Appendix E
Preliminary Implementation Schedule for
Soil RFI/RI Work Plan

Appendix F
Summary of Proposed Sampling Program
(Planned Sample Table)

**FIGURE J-1
STAGING AREAS**
DISPLACED SOIL AND HAZARDOUS WASTE
MANAGEMENT PROCEDURES
PACIFIC GAS AND ELECTRIC,
TOPOCK COMPRESSOR STATION,
NEEDLES, CALIFORNIA

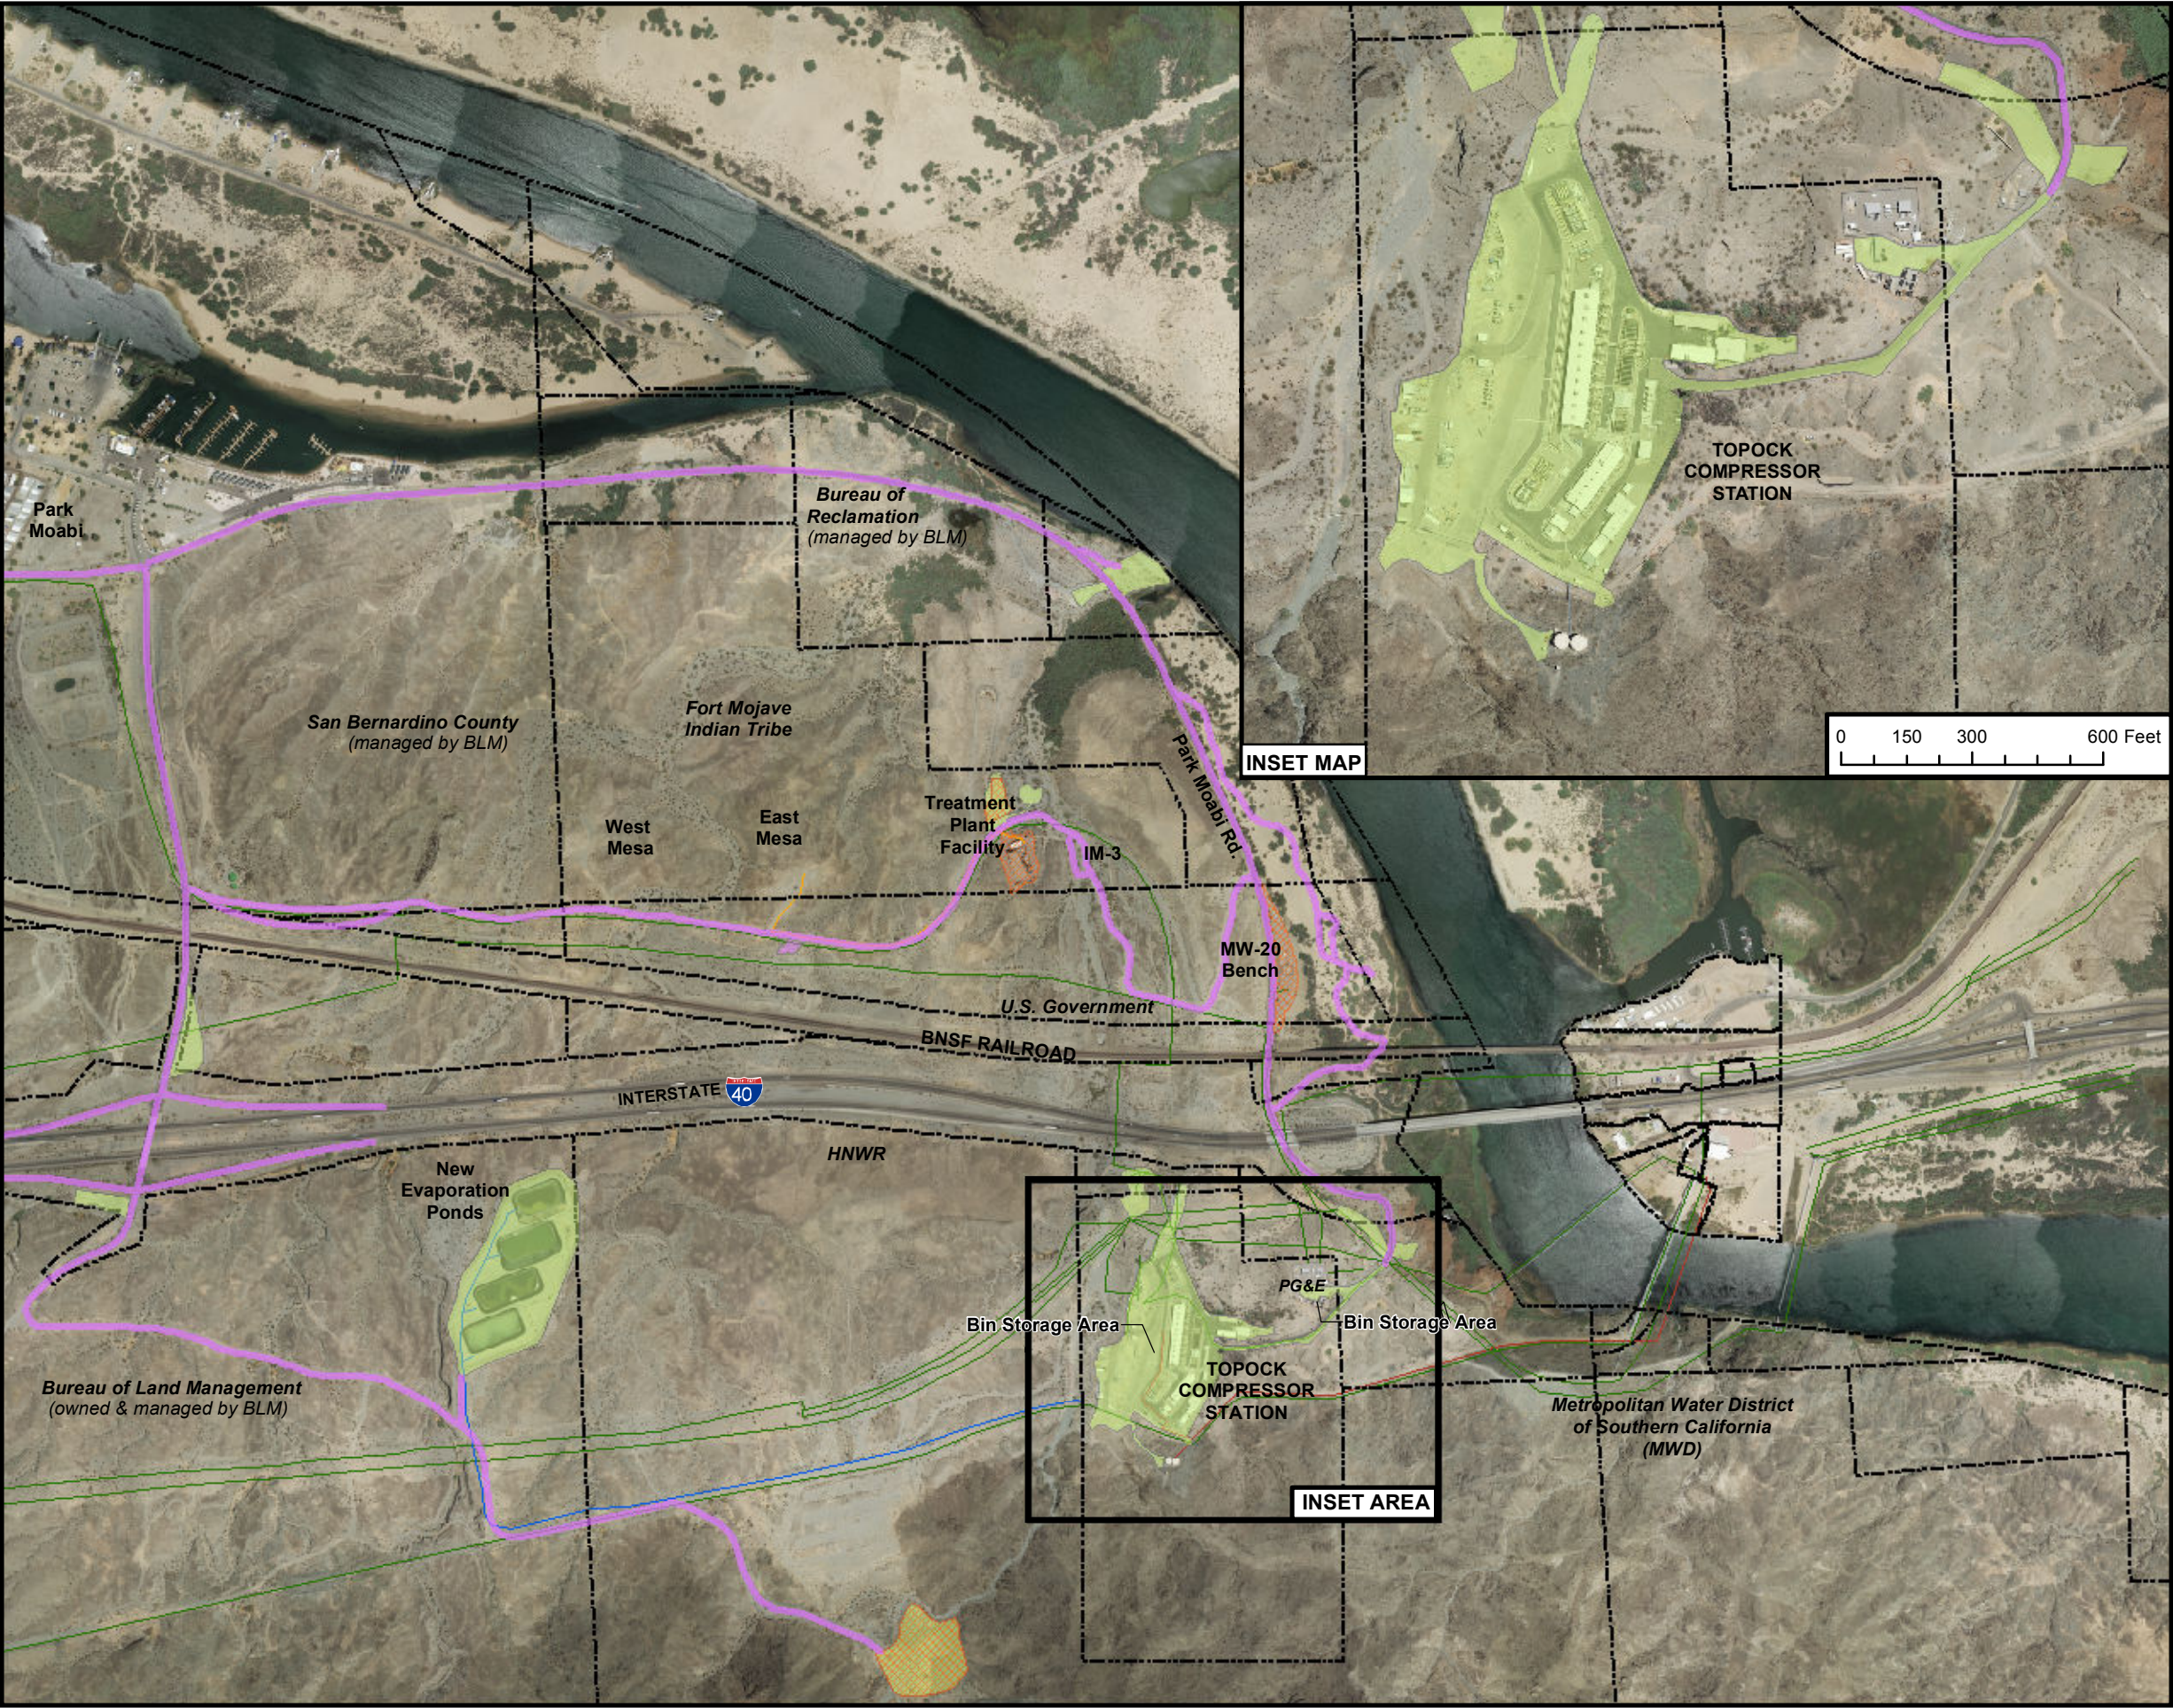
Clean soil that was removed during potholes/trenches or excavations will be reused as backfill into the same pothole/trench or excavation area, if practicable. Clean soil that was removed from boreholes cannot be used to backfill the borehole. Clean soil that cannot be immediately used as backfill may be reused in other areas within the Area of Potential Effect (APE) or left in the drums or rolloff bins for future reuse within the APE. Storage area(s) for clean soil may include all staging areas shown on Figure J-1.

compressor station fence line. The staging areas shown on Figure J-1 include the identified long-term storage areas.
